<b>DOCKETED</b>	
<b>Docket Number:</b>	24-OPT-03
<b>Project Title:</b>	Soda Mountain Solar
<b>TN #:</b>	258896
<b>Document Title:</b>	Determination of Incomplete Application and Request for Information for the Soda Mountain Solar Project (24-OPT-03)
<b>Description:</b>	N/A
<b>Filer:</b>	Ann Crisp
<b>Organization:</b>	California Energy Commission
<b>Submitter Role:</b>	Commission Staff
<b>Submission Date:</b>	9/3/2024 4:44:23 PM
<b>Docketed Date:</b>	9/3/2024

## **Determination of Incomplete Application and Request for Information for the Soda Mountain Solar Project (24-OPT-03)**

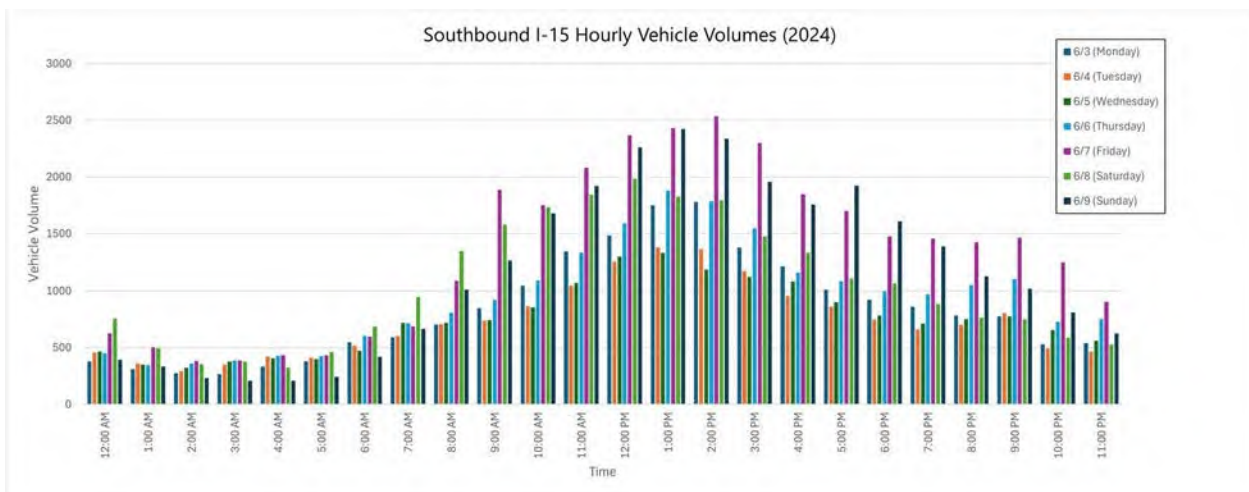
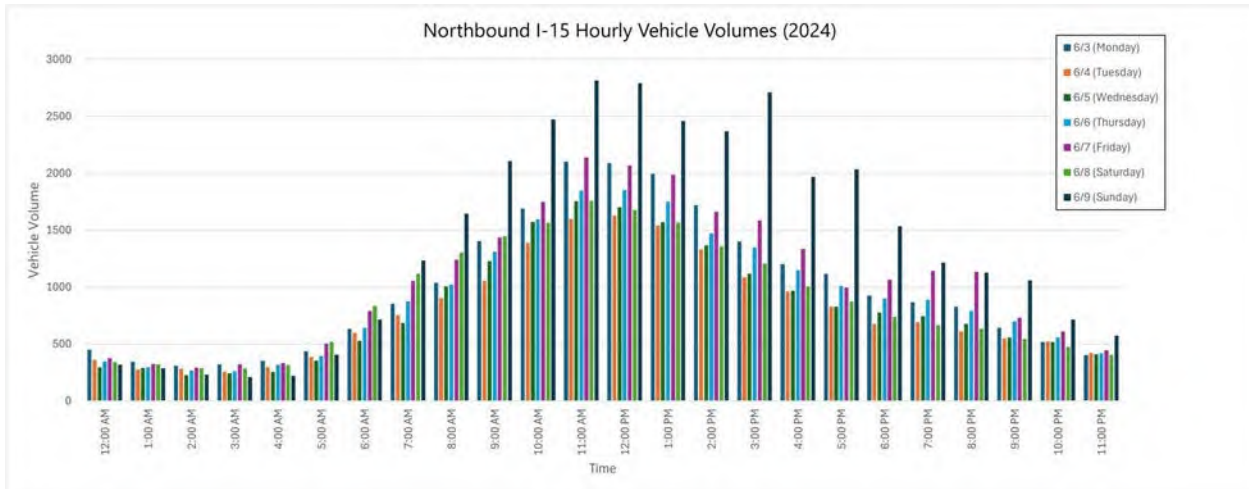
**DR TRANS-1.** There is reference in Appendix M (p. 17) to an access road to the Opah Ditch pit mine. Please provide a map that shows the location and extent of the road to be used. Please also provide a description of its nature (surface, width, etc.) and any planned improvements associated with the project.
